802.3df D3.0

Comment Resolution

P802.3df editorial team

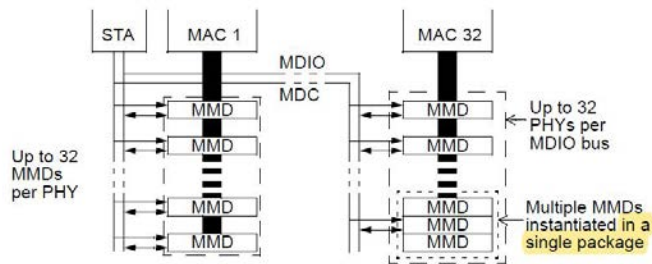
Cl 169 SC 169.4 P182 L28 # I-101
Dawe, Piers J G NVIDIA
Comment Type TR Comment Status D delay wording

It is not clear here whether e.g. a pair of IOs forming an AUI is one PMA sublayer or two. 173.5.4 says "up to four instances of the 800GBASE-R PMA within a Physical Layer", but the relation between instance and sublayer is not given there. 120.5.4, Delay constraints, says "...up to four PMA stages in a PHY (sum of transmit and receive delays at one end of the link) but it's still ambiguous. In 173.5.4, Delay constraints, "...up to four instances of the 800GBASE-R PMA", and the numbers for the PMA in Table 173-1 (not this table 169-4) apply to an instance not a sublayer.

In 173.5.3.5 we have "group of PMAs" which is not explicitly defined: maybe it means any stack of nothing but PMA-things between PMD and PCS, which could be OK for this project but may need more careful definition if an inner FEC is put between or within PMA-things.

Consolidate the terminology (don't use "sublayer" and instance" for the same thing), and explicitly state somewhere whether a pair of IOs forming an AUI is one PMA sublayer or two. Add cross-references as appropriate, e.g. from the AUI annexes.
Write something like "Each instance of a PMA" in the Notes column. Change the heading of the left column to "Sublayer or instance" if appropriate.

PROPOSED ACCEPT IN PRINCIPLE.

Change "Table 169-4 contains the values of maximum sublayer delay"

To "Table 169-4 contains the values of maximum delay for each instance of a sublayer"
Implement with editorial license.
